INSTRUCTIONAL BULLETIN NO. 17-09

Regarding Revised Standard Drawings

Effective February 9th, 2018 letting (November 29th, 2017 Turn-in), the following Standard Drawings have been revised. Also, Section 5, Index of Standard Drawings, of the Roadway Design Guidelines has been revised to incorporate these changes.

STATE OF TENNESSEE
DEPARTMENT OF
TRANSPORTATION

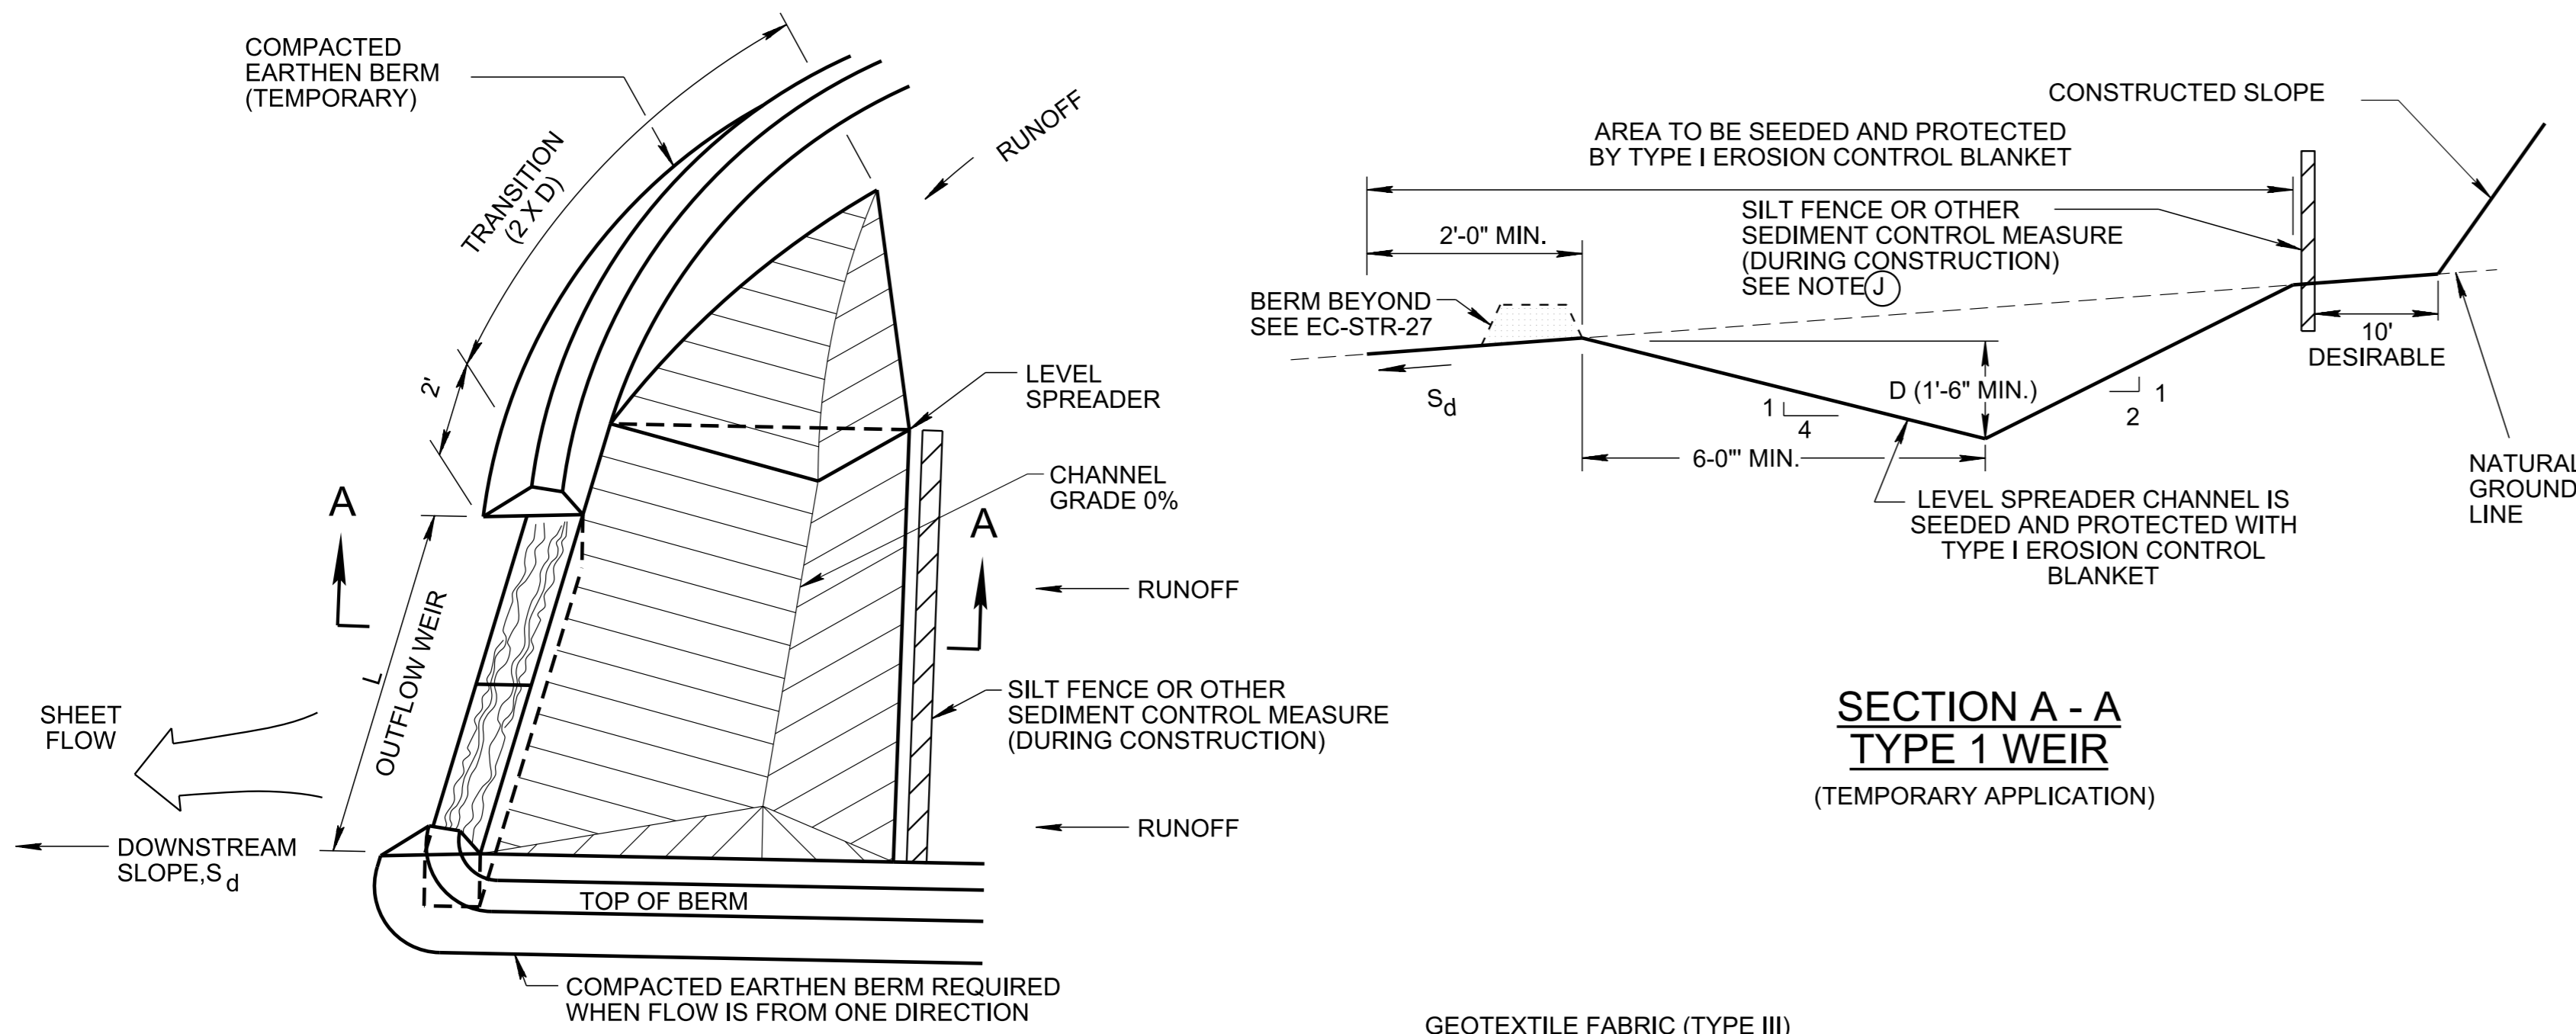
REV. 3-16-17: CORRECTED PAY ITEM NO. 209-05.

SPECIAL CASE
GUARDRAIL HEIGHT
TRANSITION
DETAIL

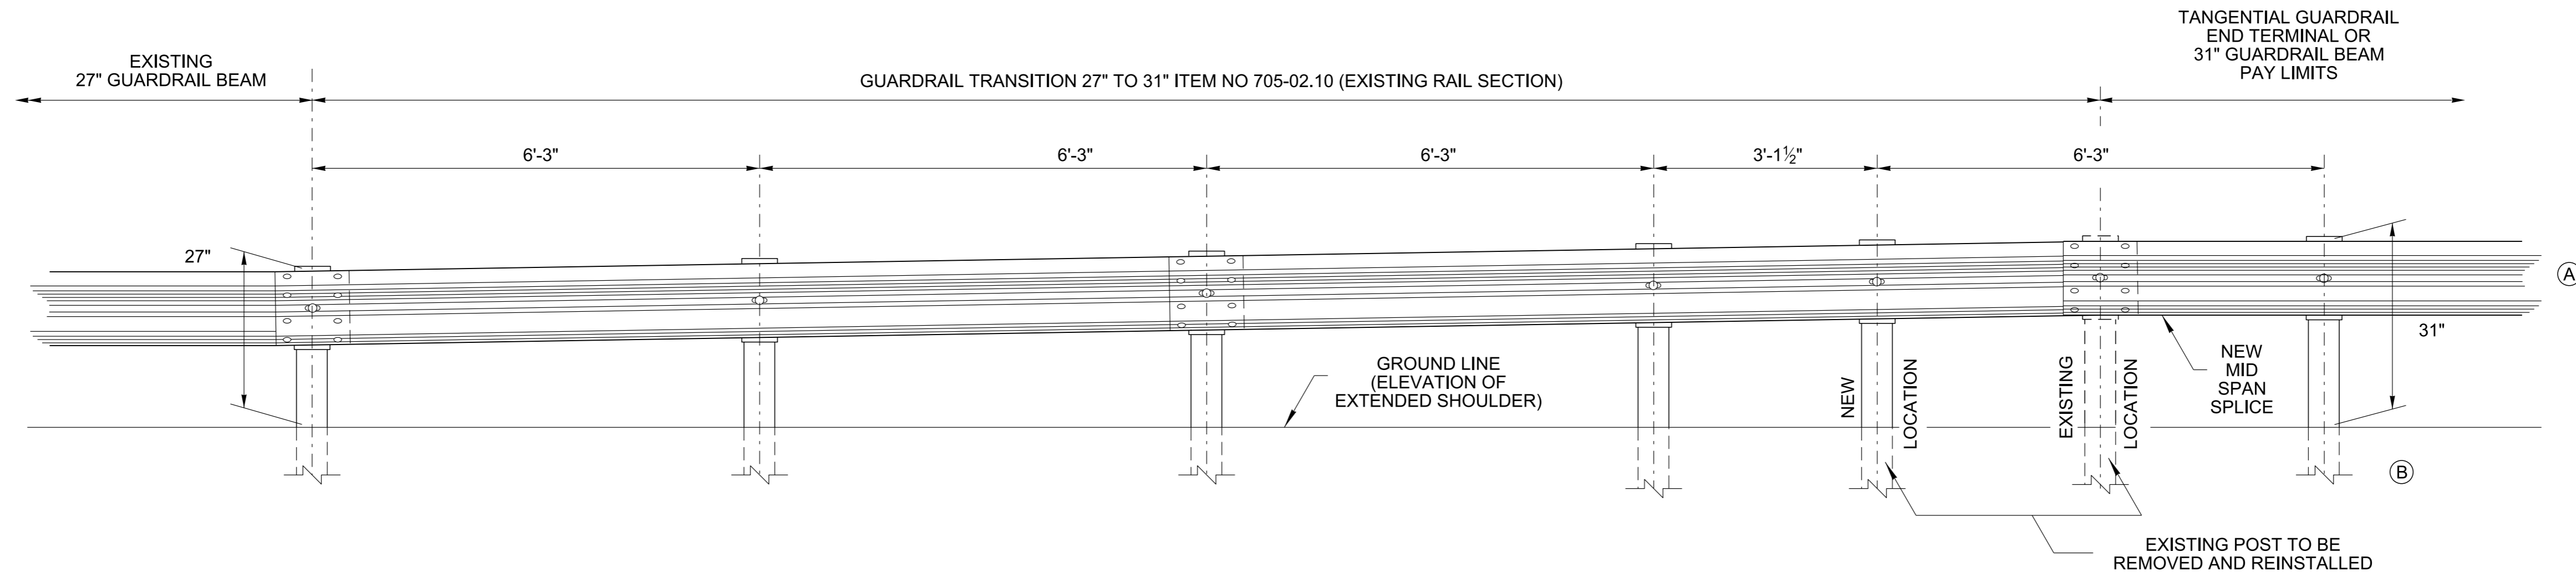
- REV. 4-12-16: ADDED PAY ITEM.
- REV. 3-16-17: CLARIFIED PAY ITEM LIMITS AT BOTH ENDS OF TRANSITION.
